SCI-823-0.00

PID No. 77366

SR 823 OVER SLOCUM AVE (TR 248)

PRELIMINARY DESIGN REPORT SUBMITTAL

SITE PLAN
 SC1-823-0.00
 PID 77366

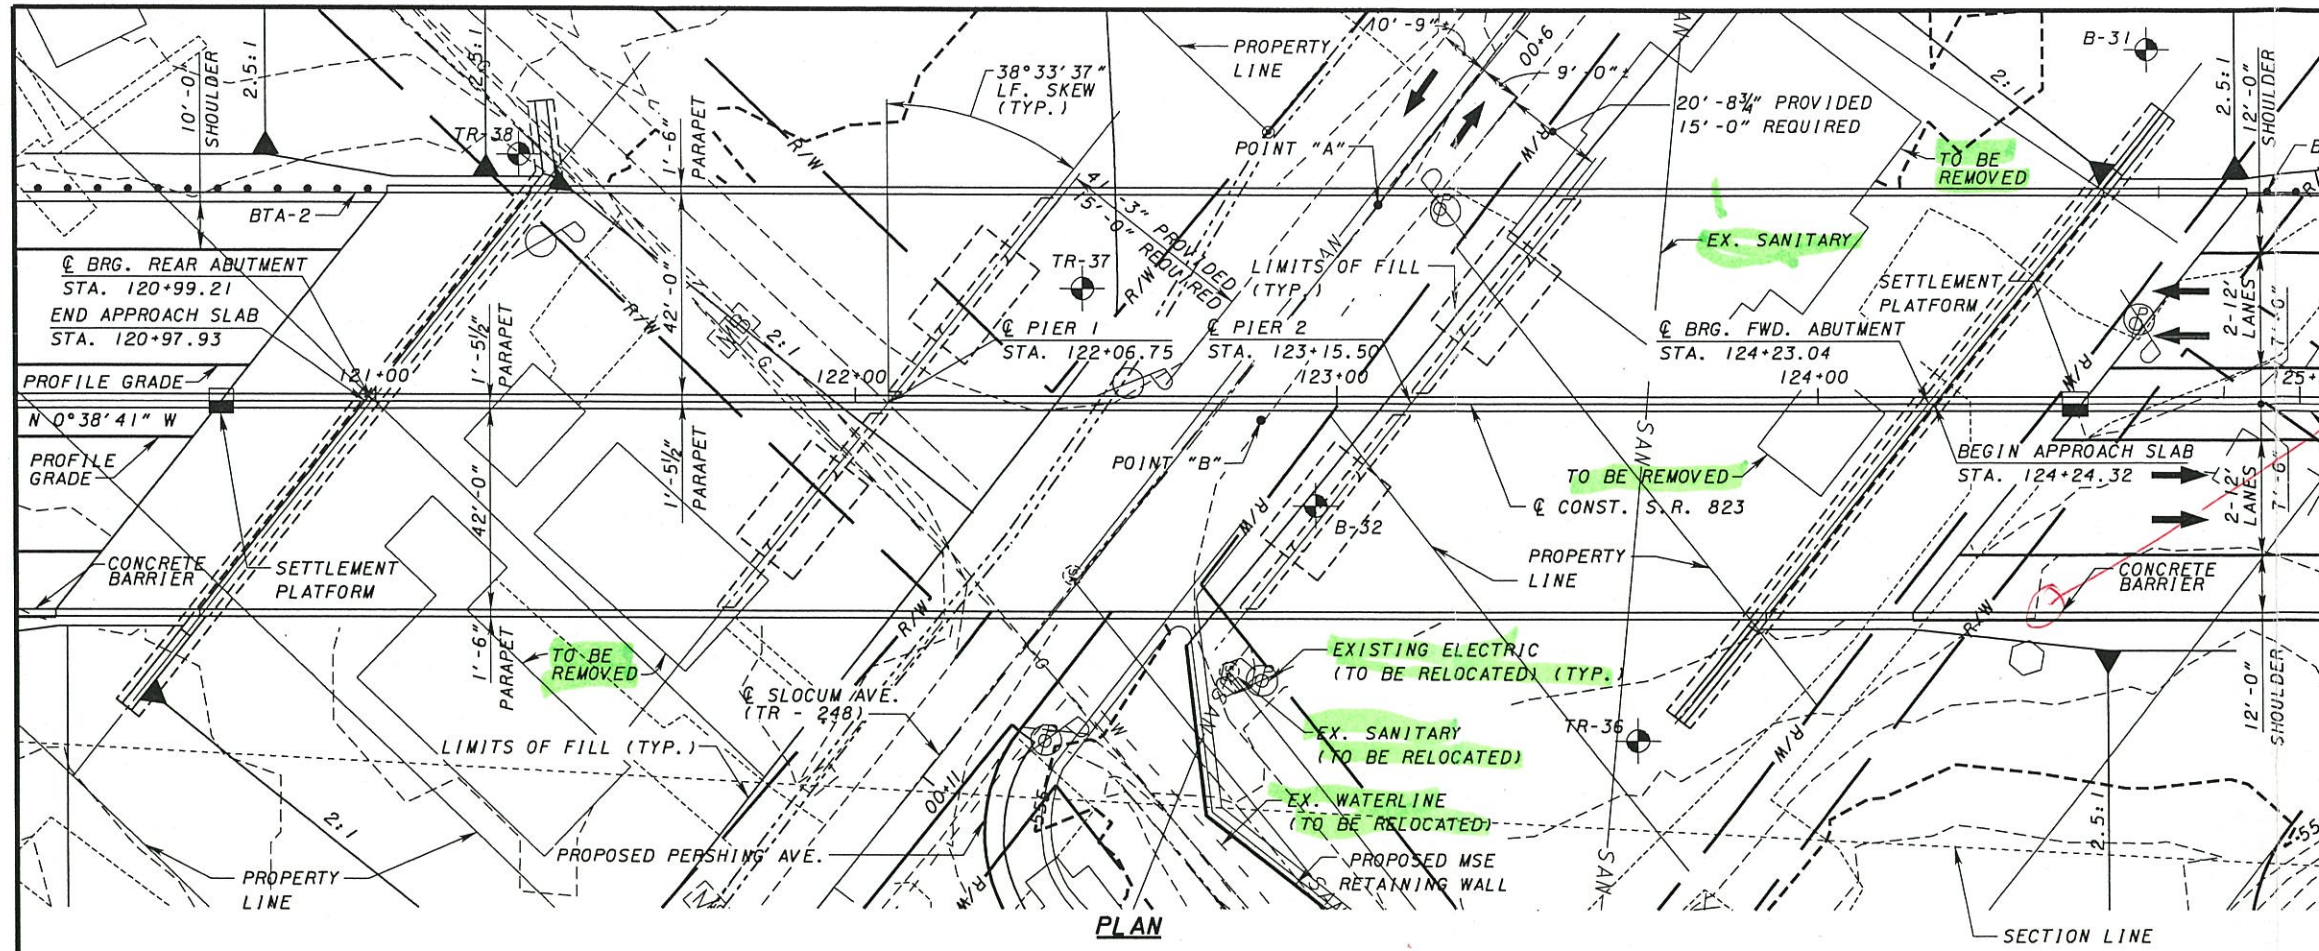
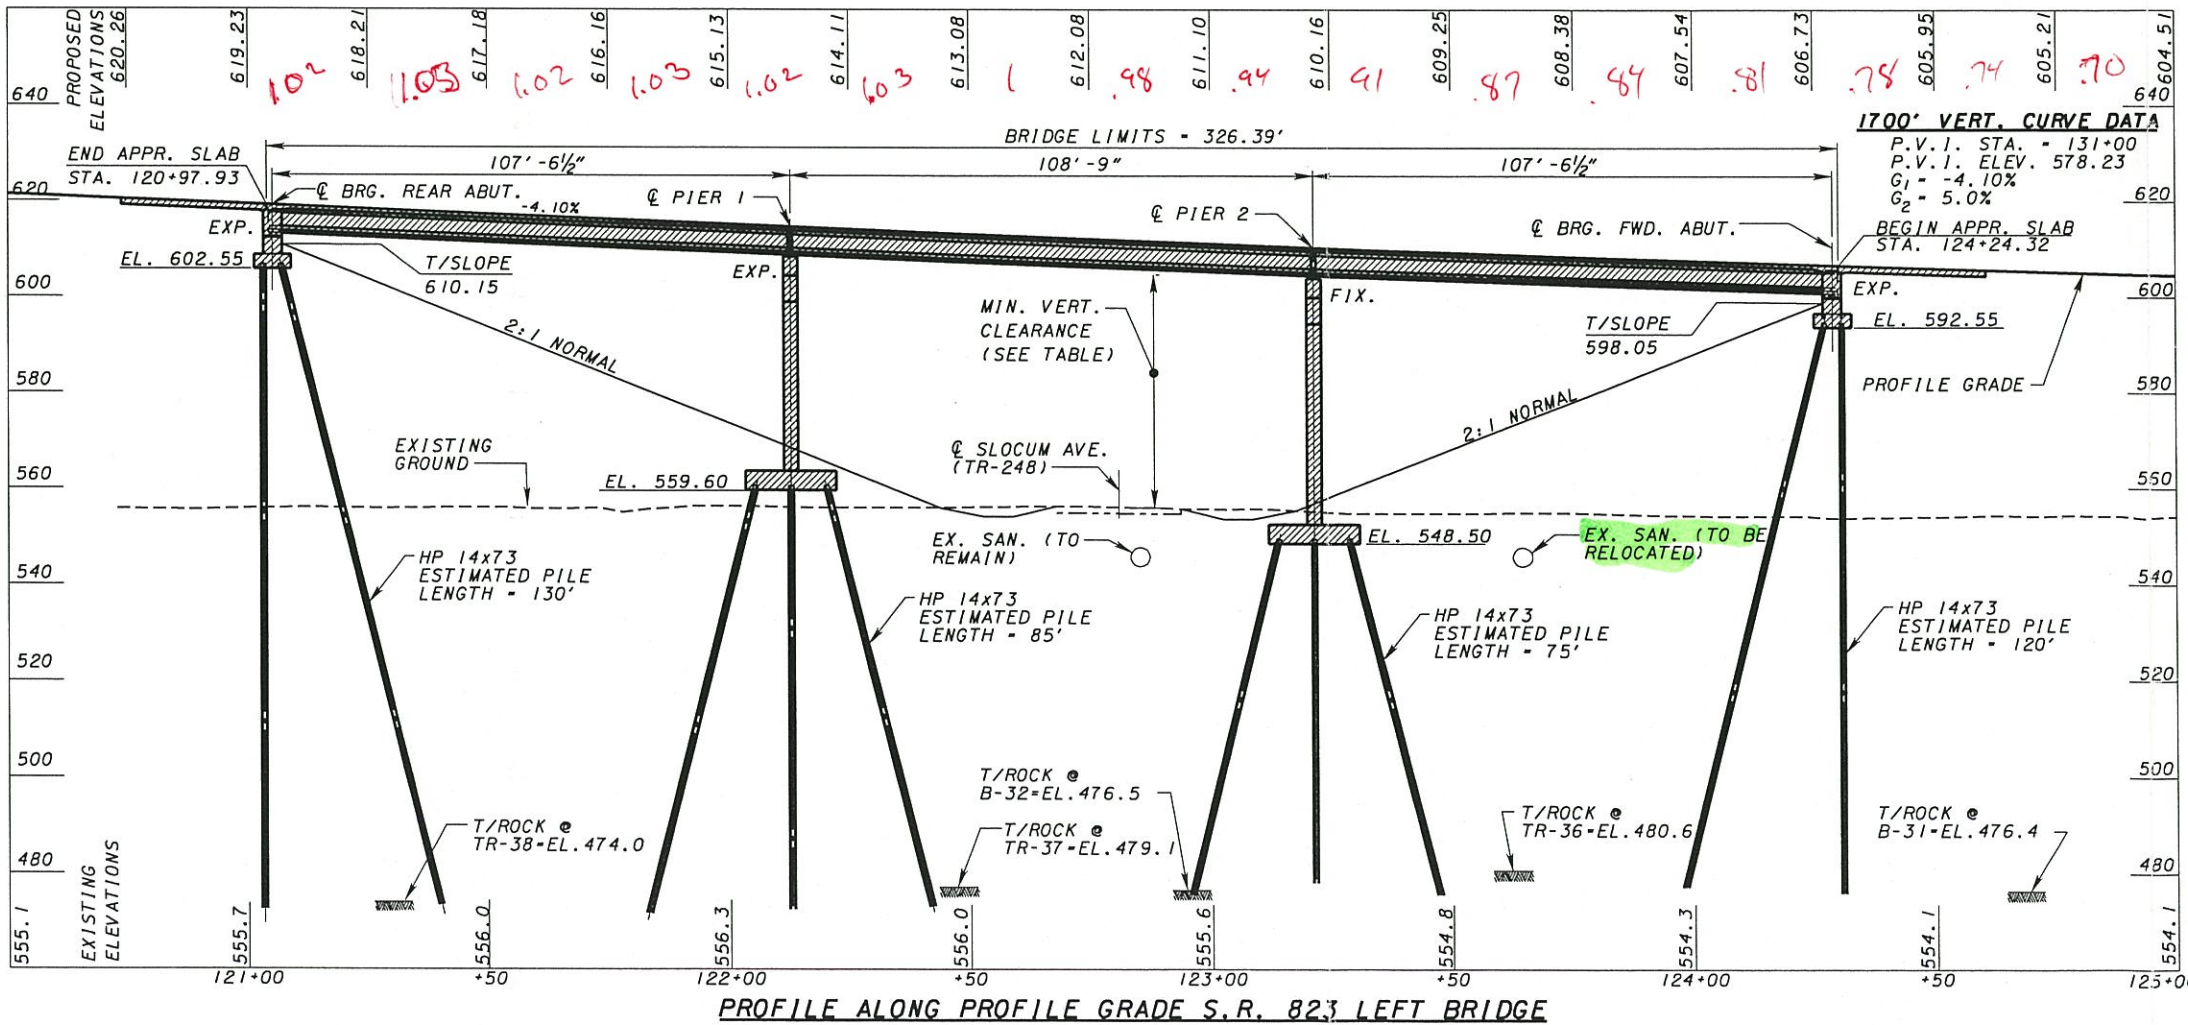
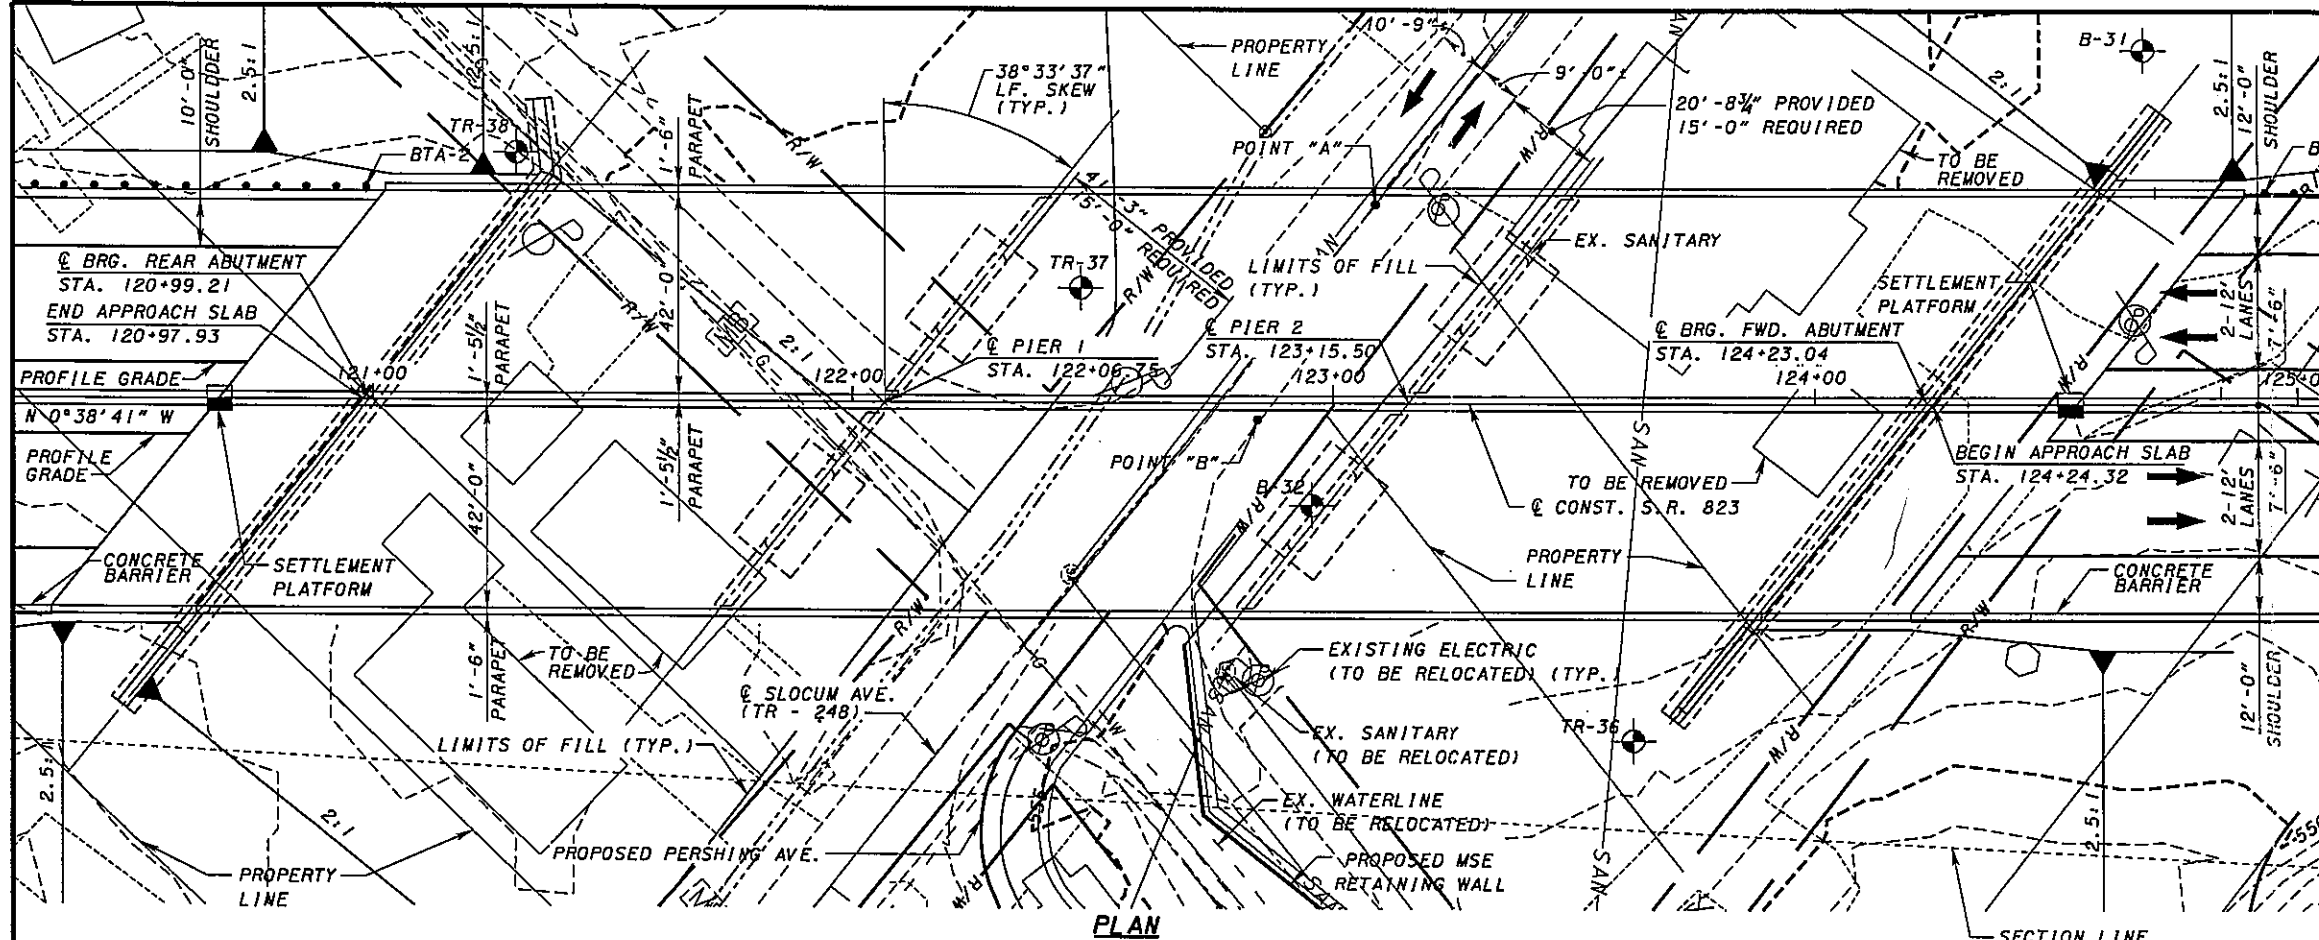
- 1. We agree with the disposition of all comments except for number 5. The span length given in the Proposed structure Block should be measured from centerline to centerline of bearings (example: centerline of bearing at abutment to centerline of bearing pier), see the ODOT Bridge Design Manual, section 201.2.2F.*

The measurement of the spans has been revised in the proposed structure data block.
